Bid Addendum No. 2 for:

MASON TRANSIT AUTHORITY – PARK AND RIDE CONSTRUCTION PROJECT

All Bidders are required to make the following substitutions to the Bid Documents. Below is a description of the revisions made to the Contract Documents.

LIGHTING AND SECURITY PLAN

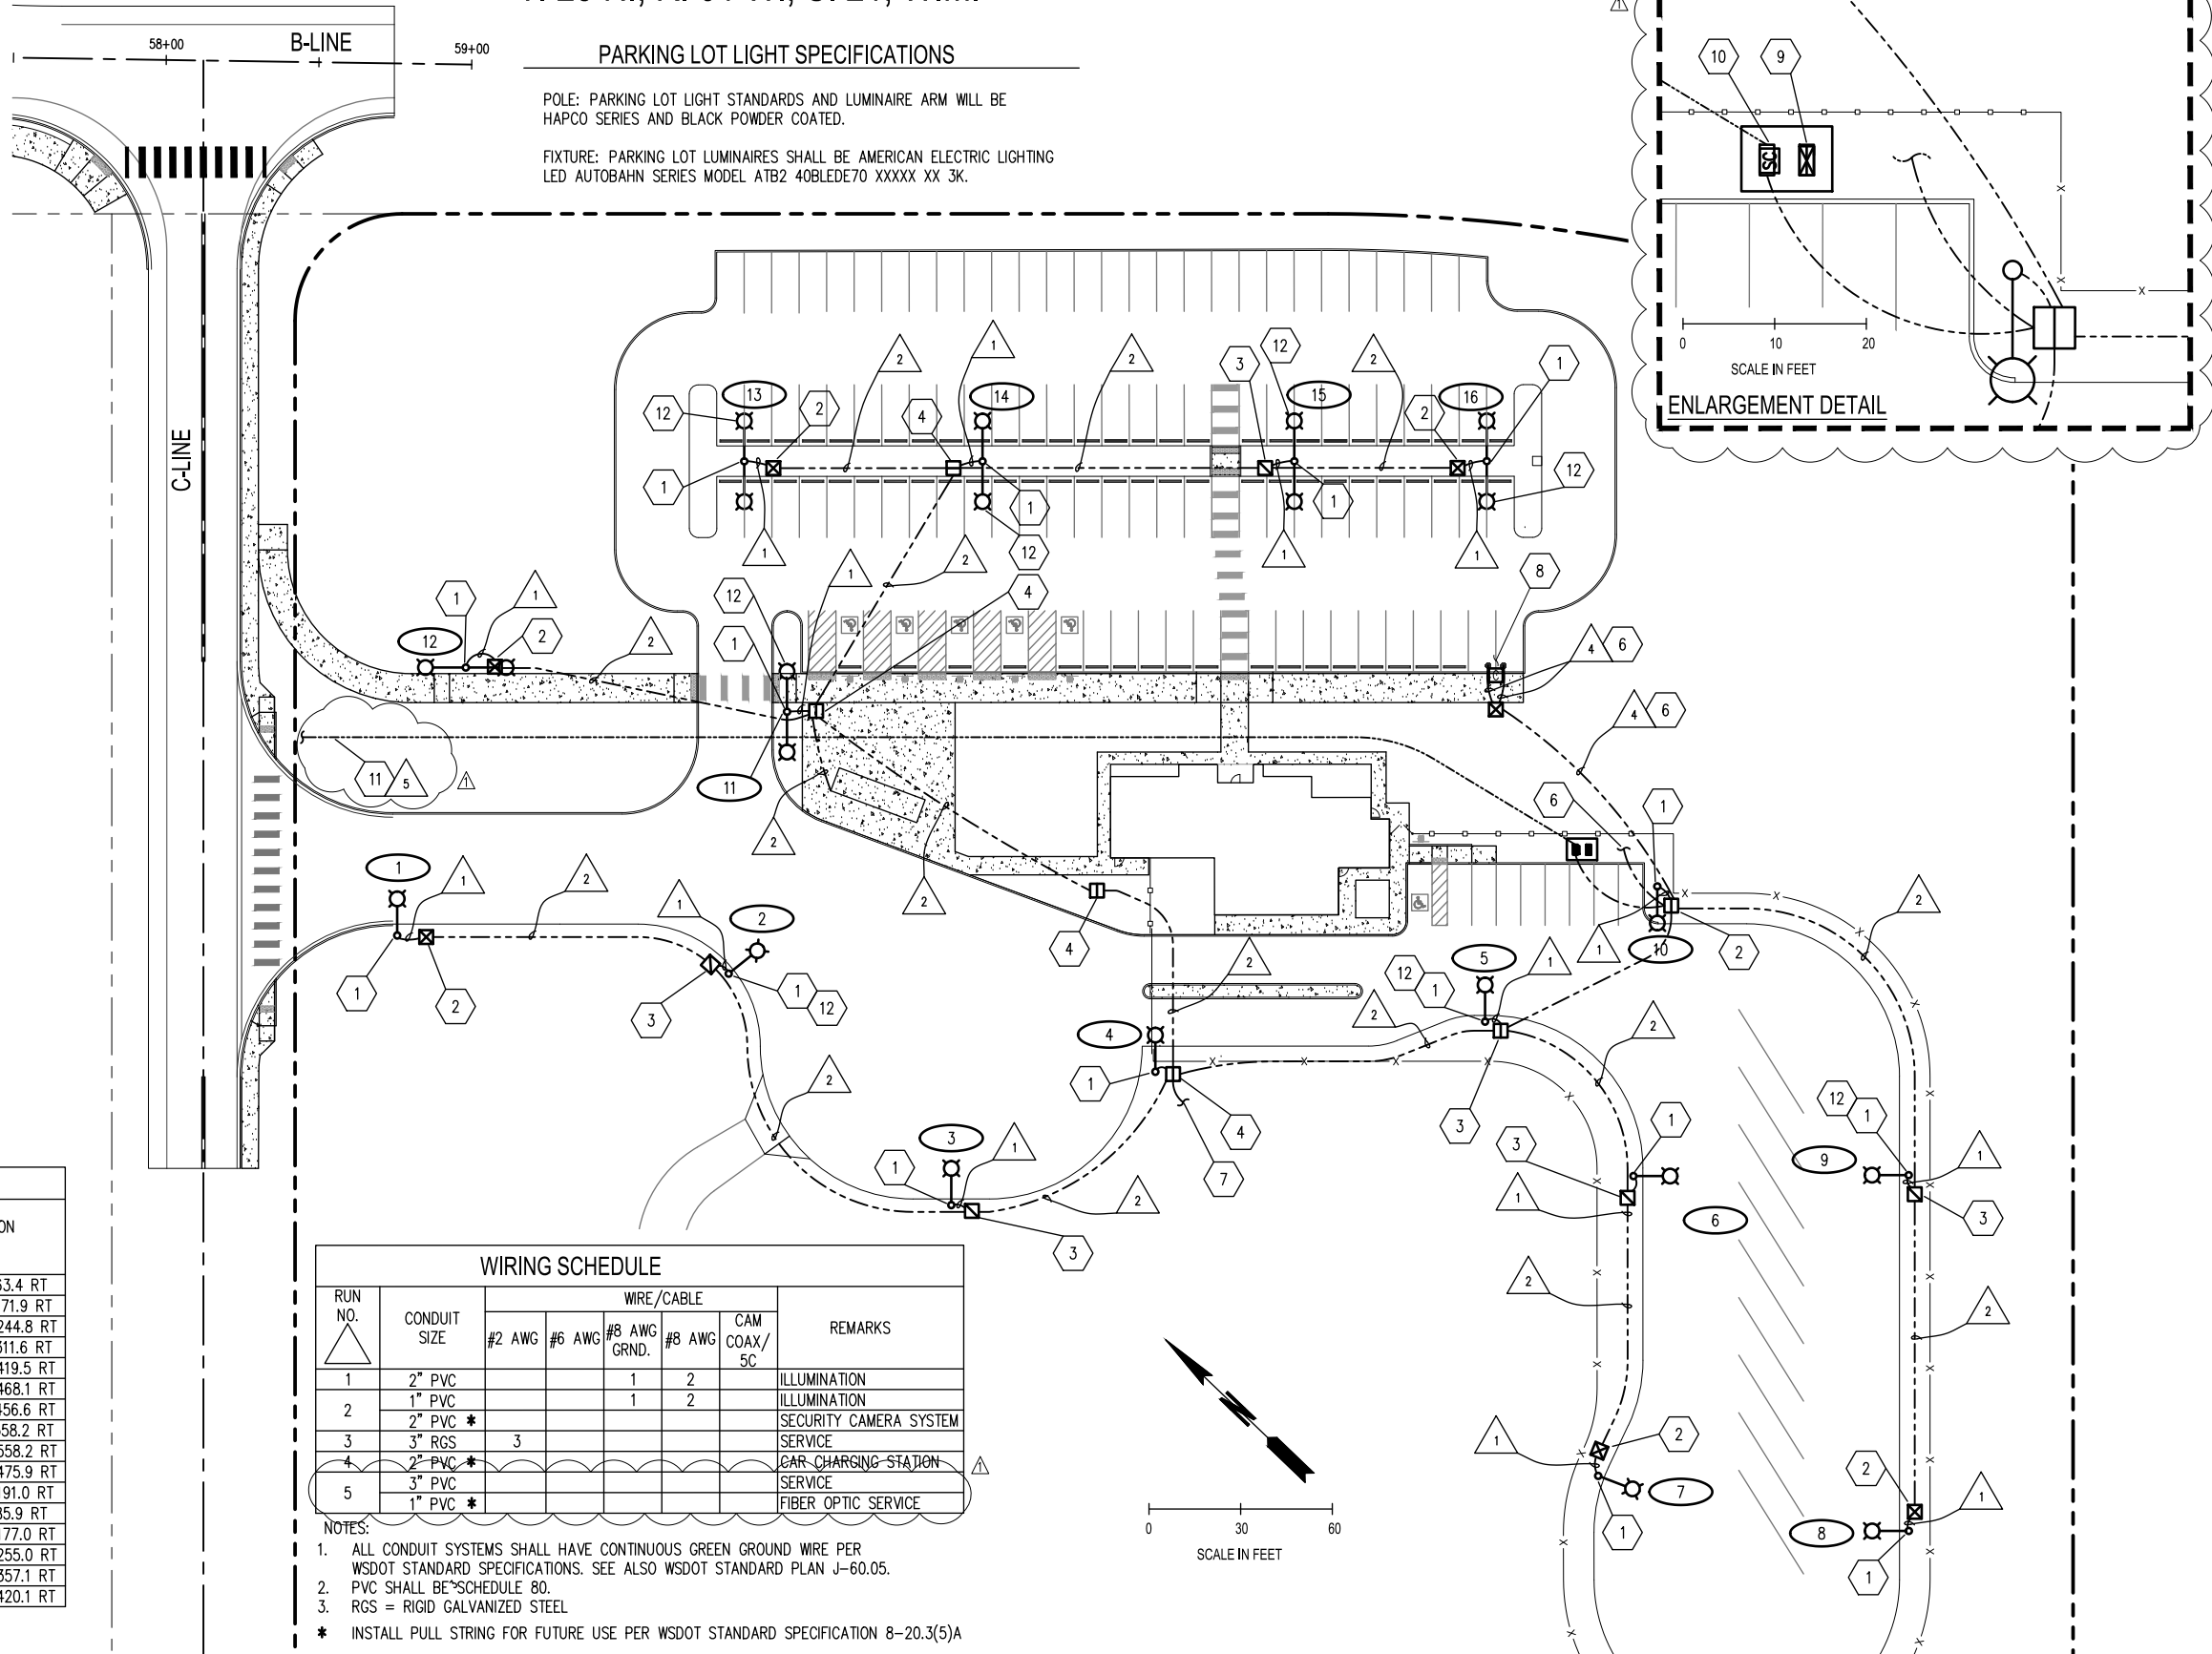
- Sheet II-1: Replace with attachment II-1 to include enlargement detail and modified luminaire heads with security camera model.
- Sheet E5.1A and E5.1B: **ADD** to Feeder Schedule:
Call-out 200-4 indicates 2”C – 4 #3/0 (CU conductors)

ILLUMINATION

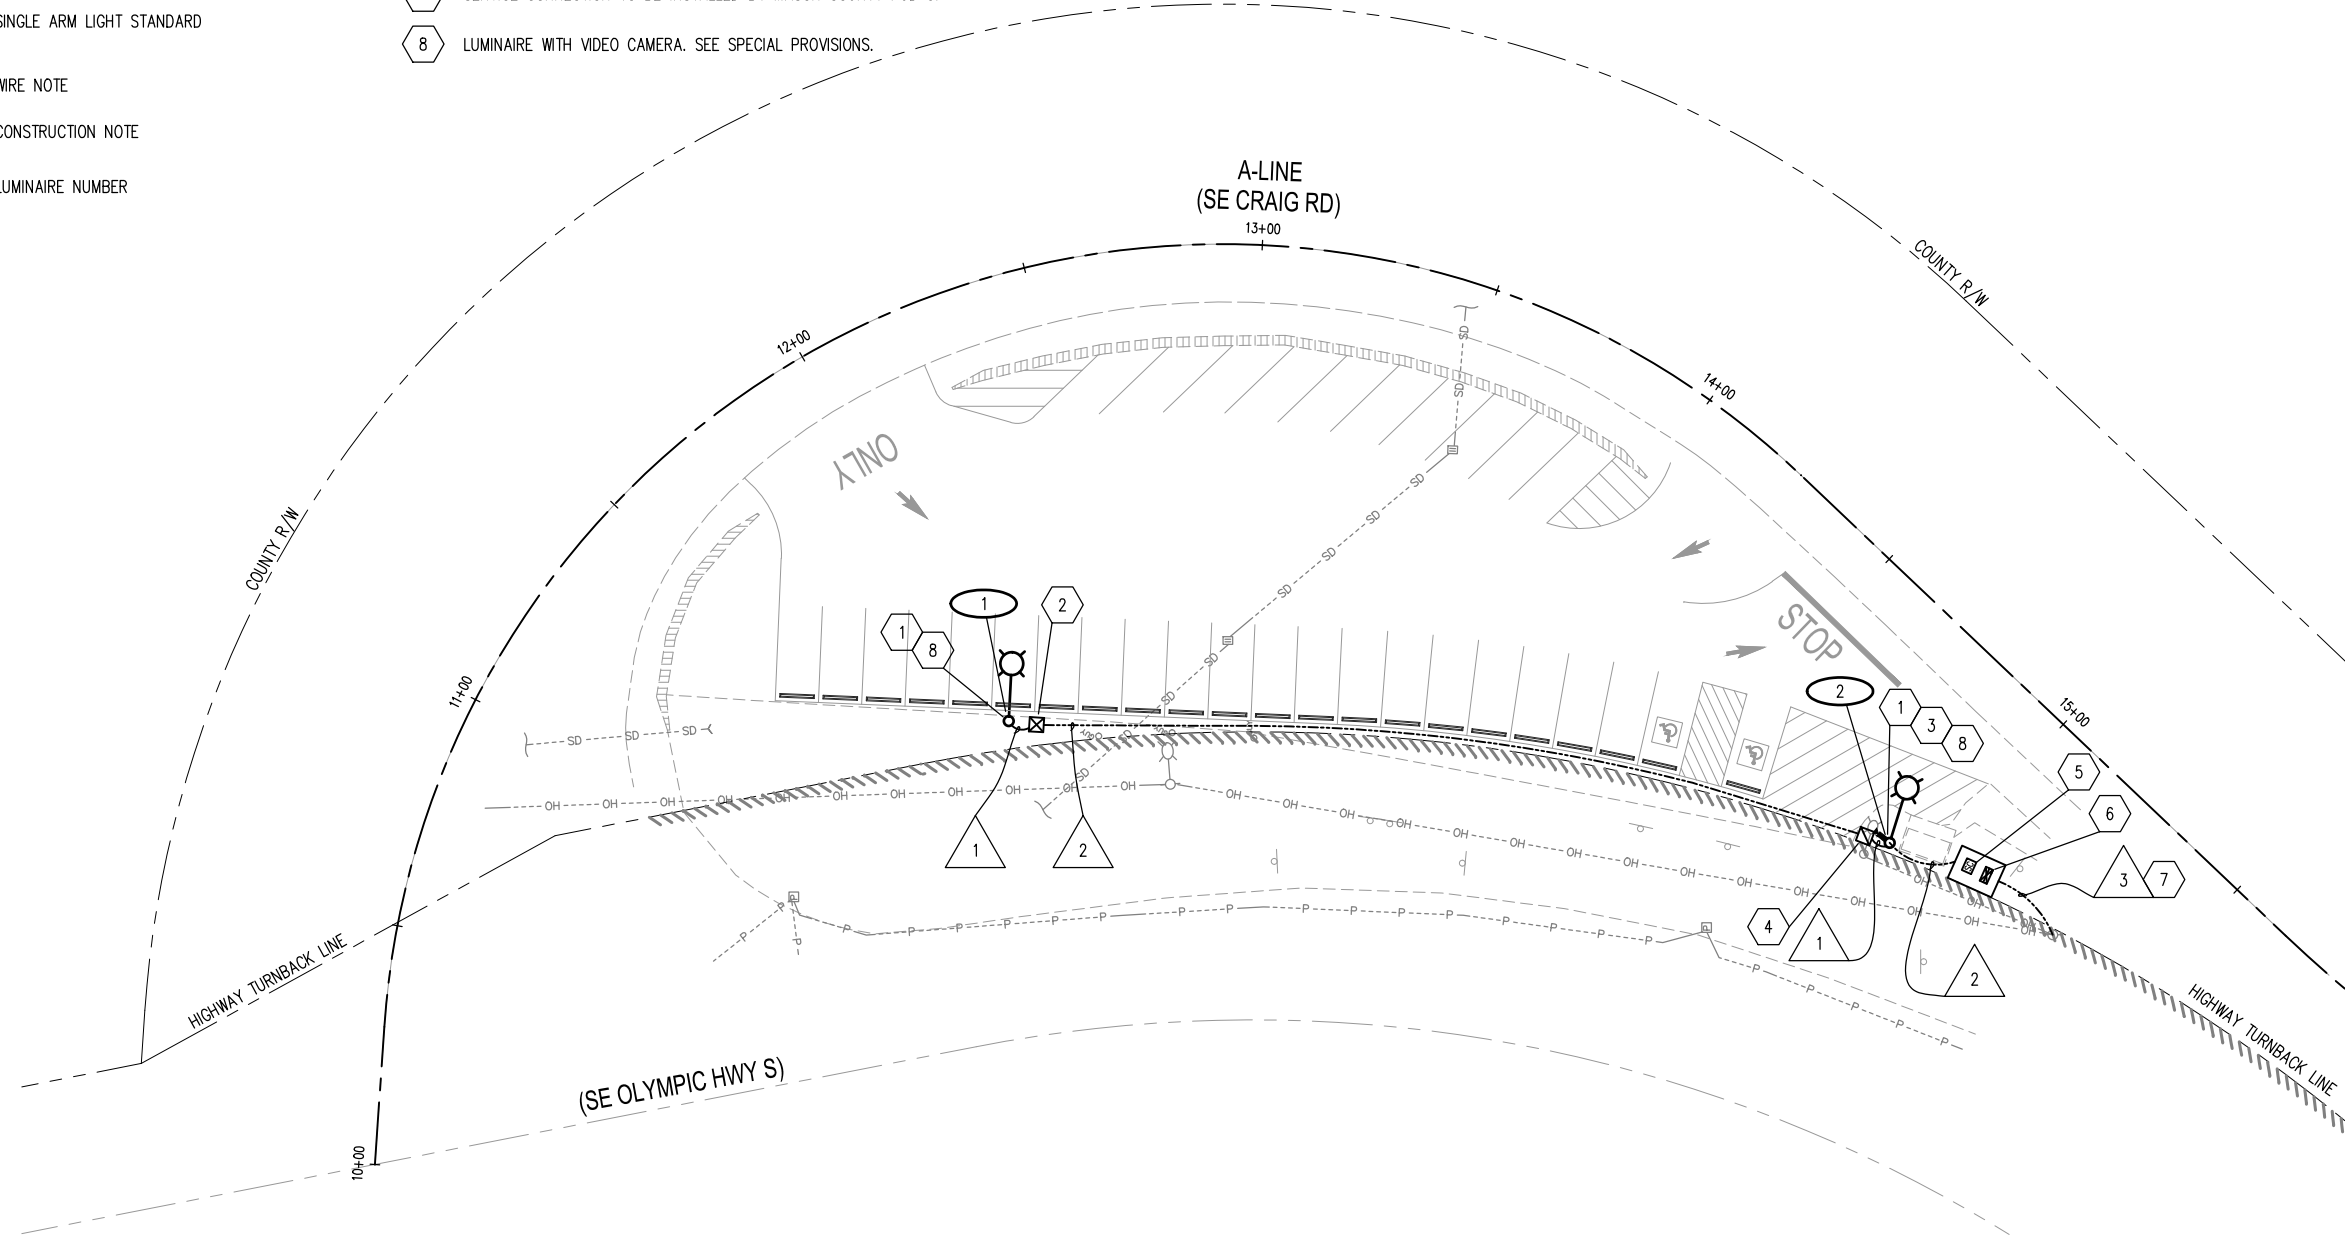
- Sheet II-1: Replace with attachment II-1 to include modified luminaire heads with security camera model.

11.29.2020 9:55 AM User: mchm\mchm.dwg
 PROJECTS\0738 MASON TRANSIT AUTHORITY\0738.05 MTA PARK AND RIDE DEVELOPMENT\CADD\PICKERING ROAD\0738.05-IL-1-P.DWG

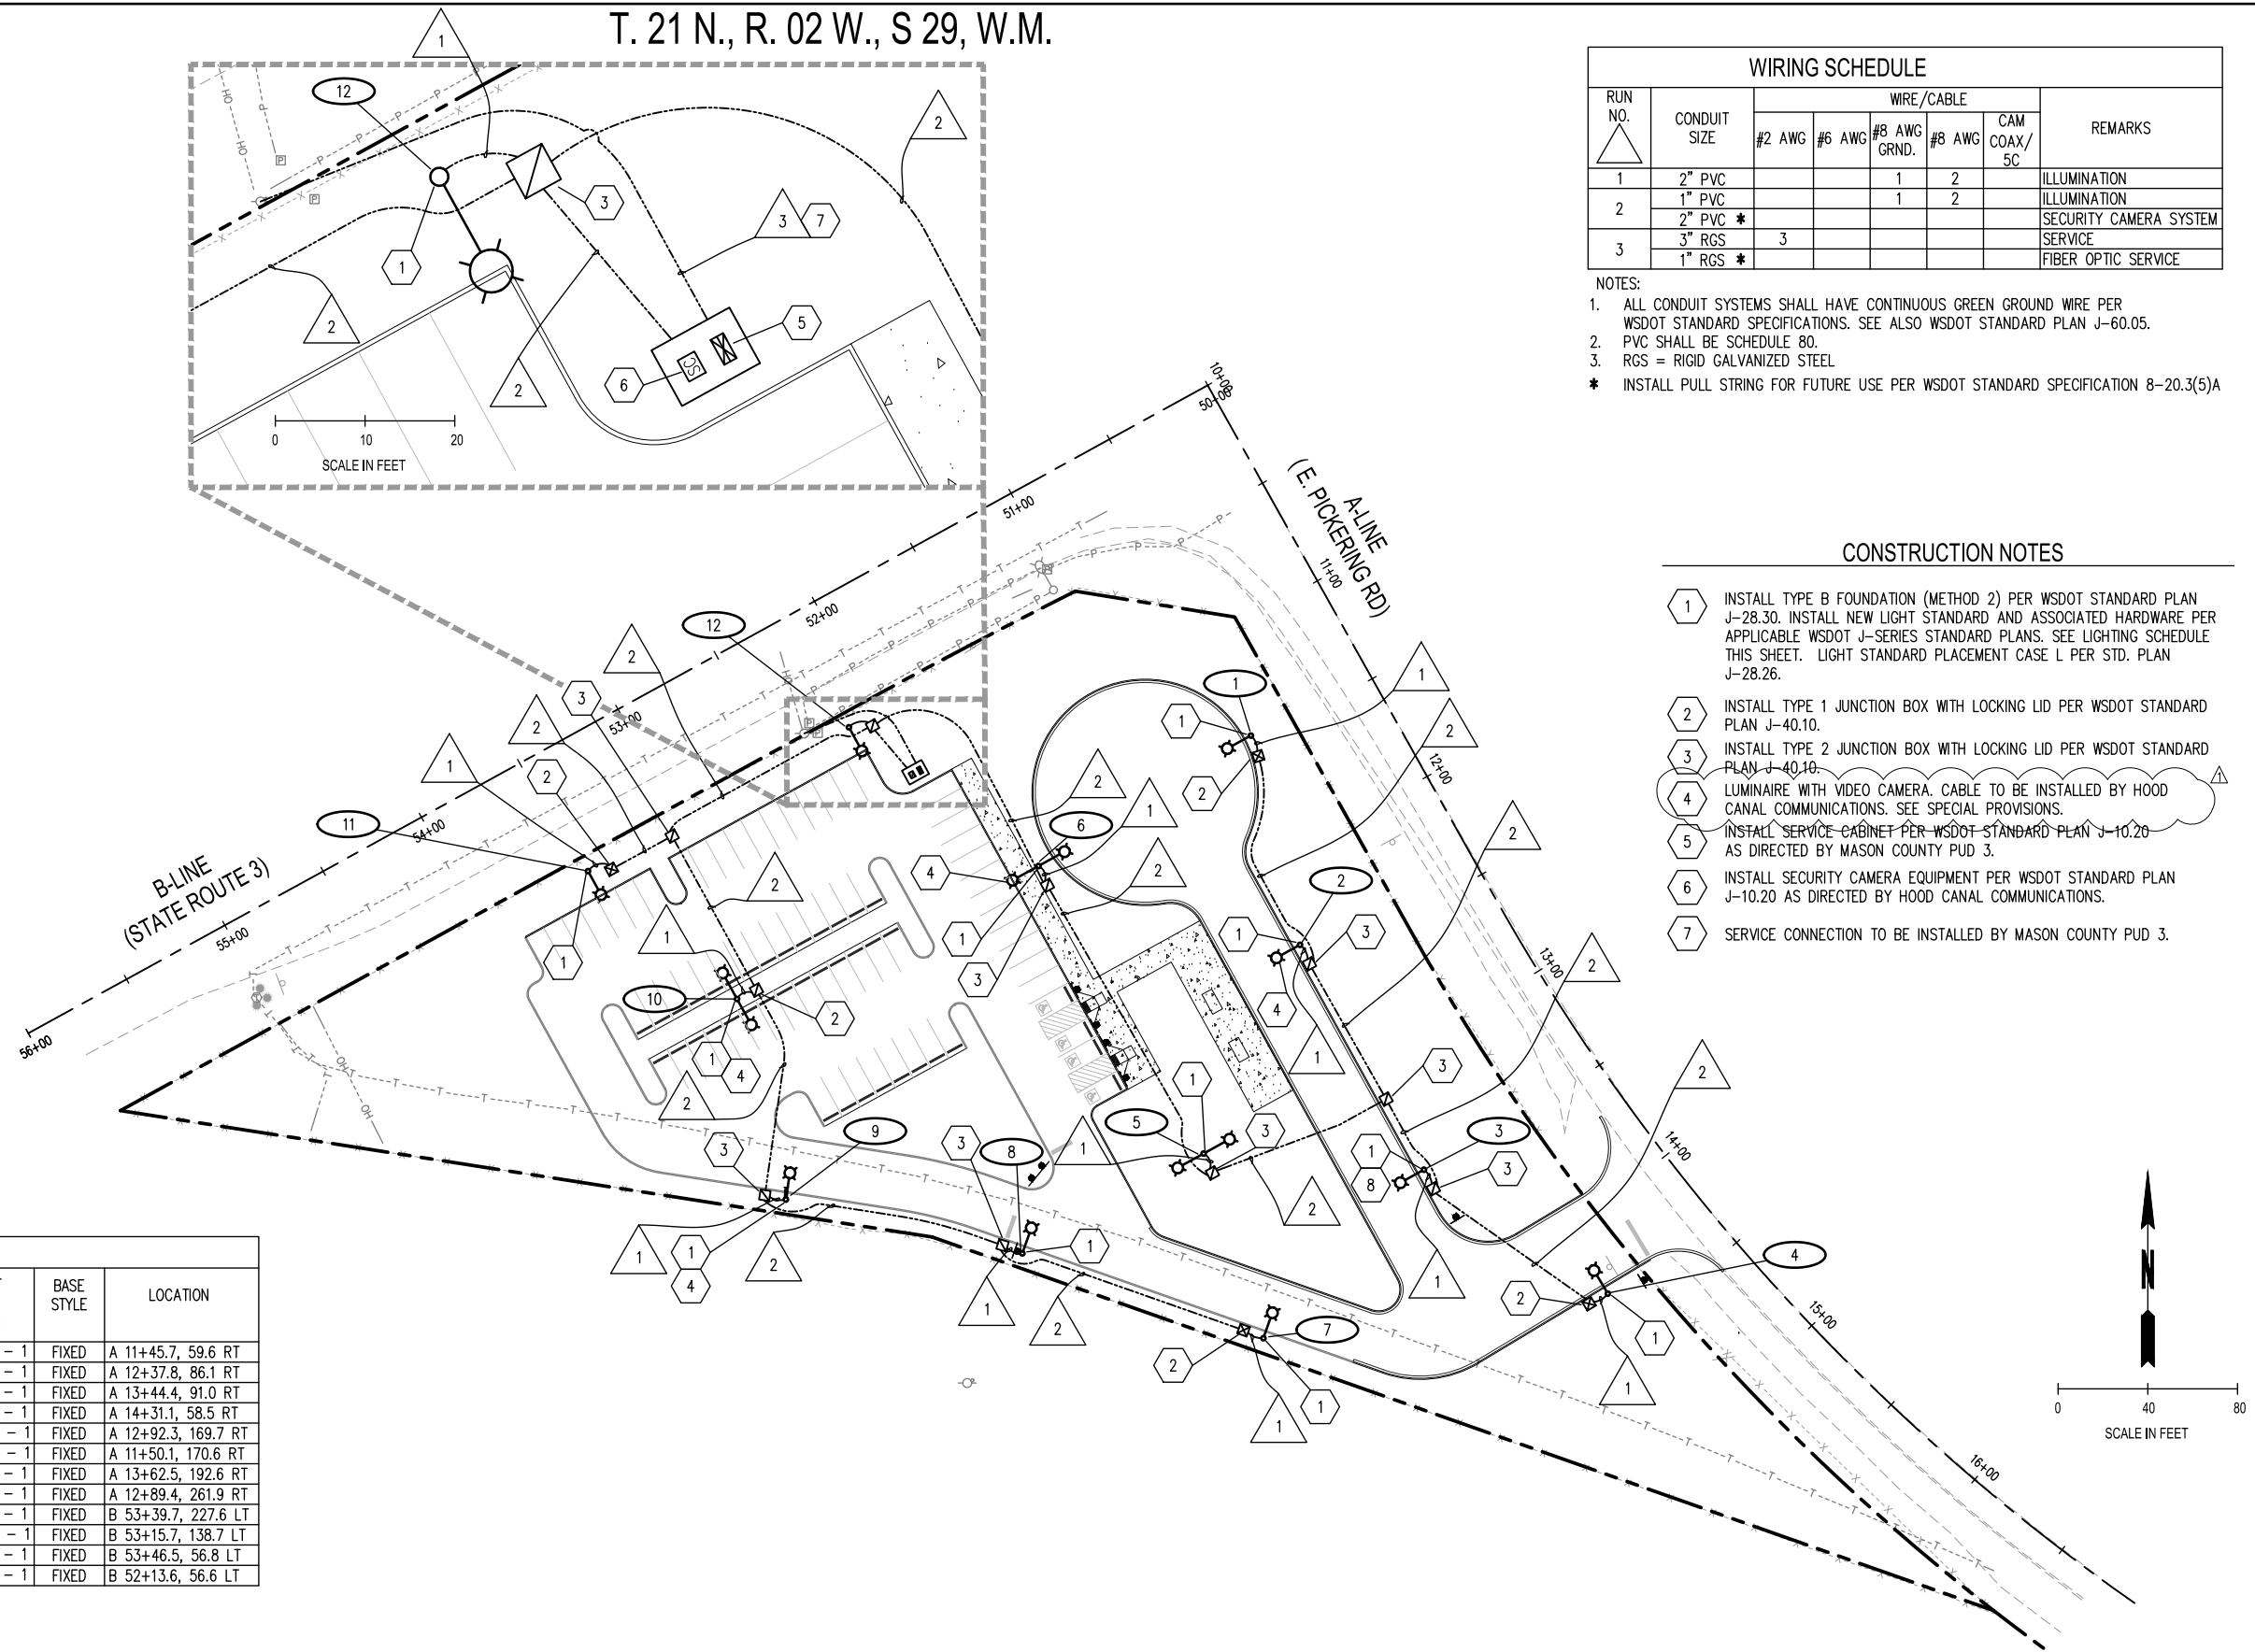
- Sheet II-1: Replace with attachment II-1 to include modified luminaire heads with security camera model.
